**Re: 16 Addison Road, Manly – DA2021/1408**

The public exhibition of this development application has recently finished. Council received a number of submissions. This letter responds to issues raised in those submissions and highlights some additional points we think are worthy of consideration by council.

Diagram 2: Building height, northern facade.

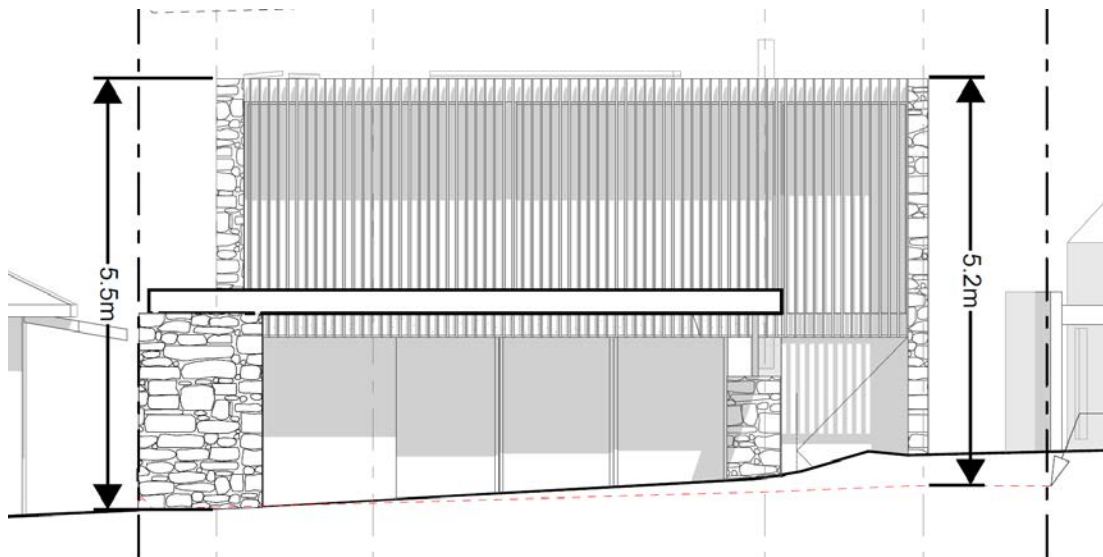
In terms of Step 4 of the *Tenacity* assessment (ie: assess the reasonableness of the proposal), the elevation of the proposed dwelling house that faces towards 12 Addison Road (ie: the north elevation) is substantially lower than the 8.5m building height control, ranging in height from 5.2m to 5.5m as shown in the following diagram:

In terms of Step 4 of the *Tenacity* assessment (ie: assess the reasonableness of the proposal), the elevation of the proposed dwelling house that faces towards 18 Addison Road (ie: the north elevation) is substantially lower than the 8.5m building height control, ranging in height from 5.2m to 5.5m, as shown in the Diagram 2 above.

In terms of Step 4 of the *Tenacity* assessment (ie: assess the reasonableness of the proposal), the elevation of the proposed dwelling house that faces towards 22-26 Addison Road (ie: the north elevation) is substantially lower than the 8.5m building height control, ranging in height from 5.2m to 5.5m, as shown in the Diagram 2 above.

Diagram 1: Views from 20 Addison Road are maintained.

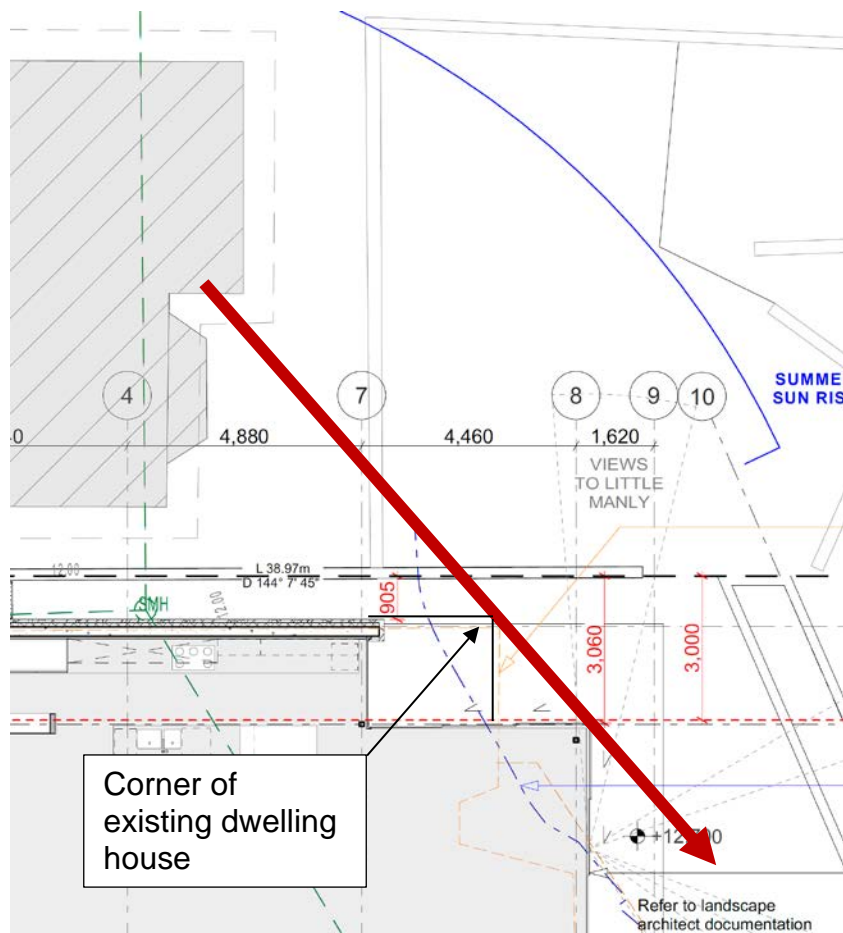
The submission from 20 Addison Road expressed a particular concern regarding views from the more eastern room. My clients wanted to retain the view for the

owners, and the tenants, of 20 Addison Rd so as part of their plan they stepped in the house on that side to achieve this outcome. The following diagram demonstrates that sight lines are essentially unchanged from this room:

In terms of Step 3 of the *Tenacity* assessment, the proposal has little if any impact on views from 20 Addison Road. The occupants of 20 Addison Road retain extensive views over Little Manly Cove, Little Manly Point, North Head and Middle Harbour. The impact assessed under Step 3 of the *Tenacity* principle is negligible.

*Diagram 2: Visual privacy to windows in 20 Addison Road are maintained.*

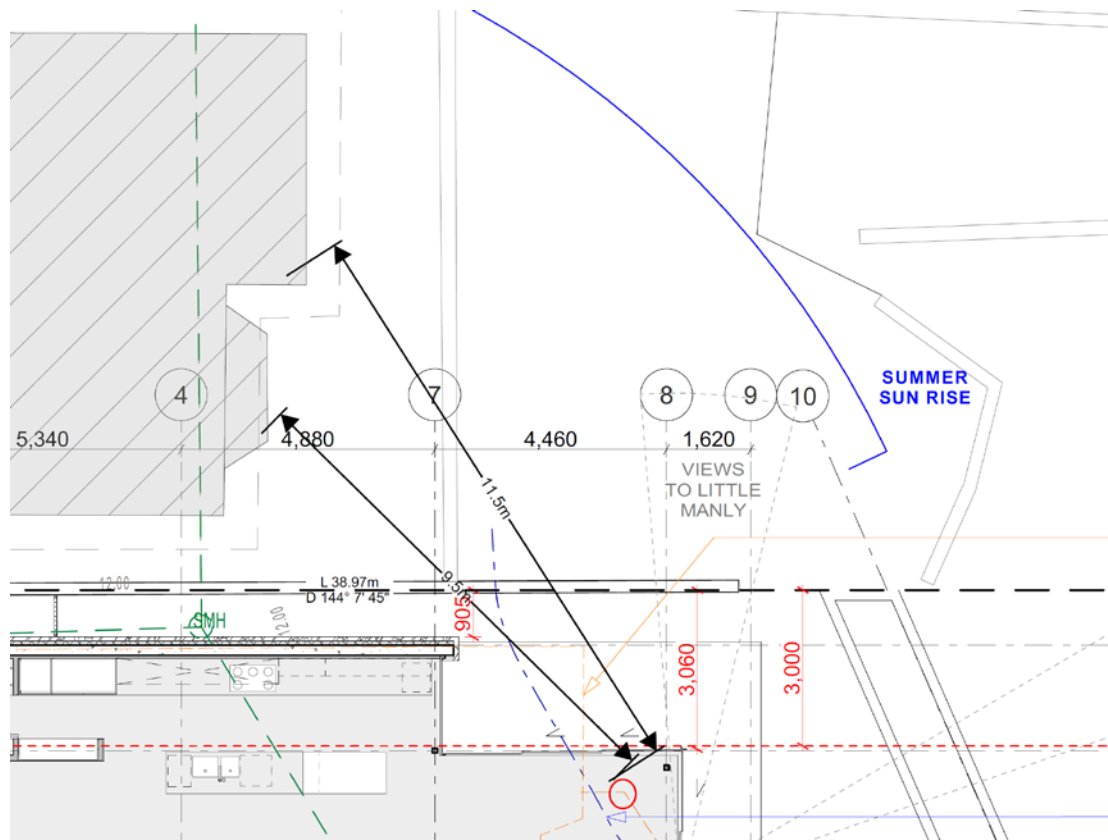
Sight distances from the windows of the proposal to the windows of 20 Addison Road exceed 9 metres, which is sufficient to mitigate privacy impacts. The distance to the bay window is 9.5m and to the sunroom is 11.5m, as shown in the following diagram.

Furthermore, in order for people in the proposed dwelling house to look into the windows of 20 Addison Road they would need to stand in the north east most corner of the house and look back towards No20 (away from the view). This is an unnatural and unlikely event and would require effort. Put another way, there is very little chance of casual or sustained privacy impact. Overlooking impacts on No20 are further mitigated by the fact that to the extent that people inside the proposed dwelling house can see into No 20 it is an oblique angle that affords a view into only a small part of each of the two front rooms of No 20 and because the bedroom is an area with a low level of daytime usage. Lastly and very importantly, the harbour side room that fronts the building line in No 20 is supposed to be looked through more than it is to be lived in as all the core living areas – kitchen, dining room and sitting room – are all set back towards the street on that floor.
